The Florida Department of Transportation (FDOT) has been meeting with local officials and community members regarding two planned projects on State Road (S.R.) A1A in Cape Canaveral. The following are questions and FDOT responses related to plans to redesign S.R. A1A from Long Point Road to George King Boulevard to provide improved bicycle and pedestrian accommodations and enhance safety. Questions related to plans to realign International Drive and construct a roundabout are provided in a separate document.

1
Redesign the Intersection of S.R. A1A & N. Atlantic Ave.

2
Redesign the road from N. Atlantic Ave. to George King Blvd.

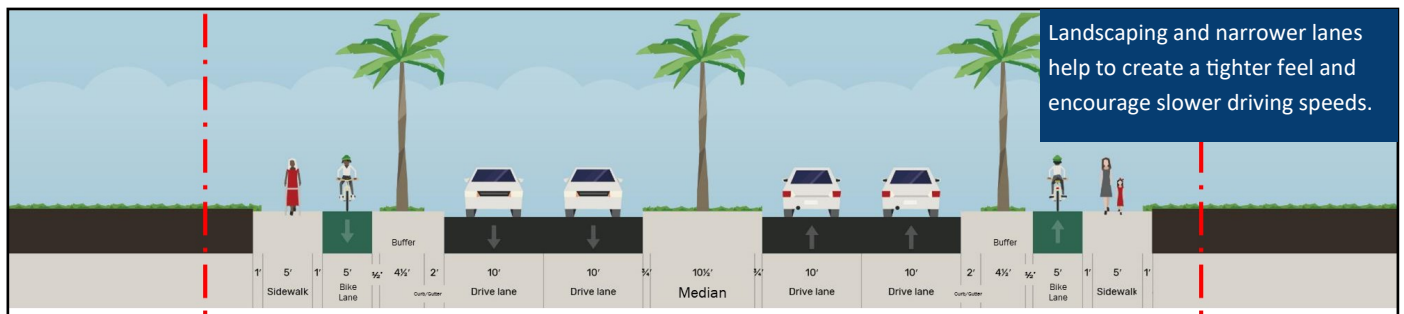
Q. There was mention of “bookends” during the Council Meeting on 3/15/22. Please explain why we need these “bookends” and how this will slow down the traffic for the entire length of project.

The modern roundabout at the south end of the project and the additional curvature (roadway deflection) at the north end of the project serve as “bookends” to slow down the traffic speeds. These “bookends” by themselves don’t contribute to the reduced speed throughout the length of the project, but we need them as they provide a starting point for the slower speed. Once the slower speeds are established at the two ends of the project, additional traffic calming features (such as raised crosswalks and additional landscape), can be introduced throughout the project to maintain the slow speeds.
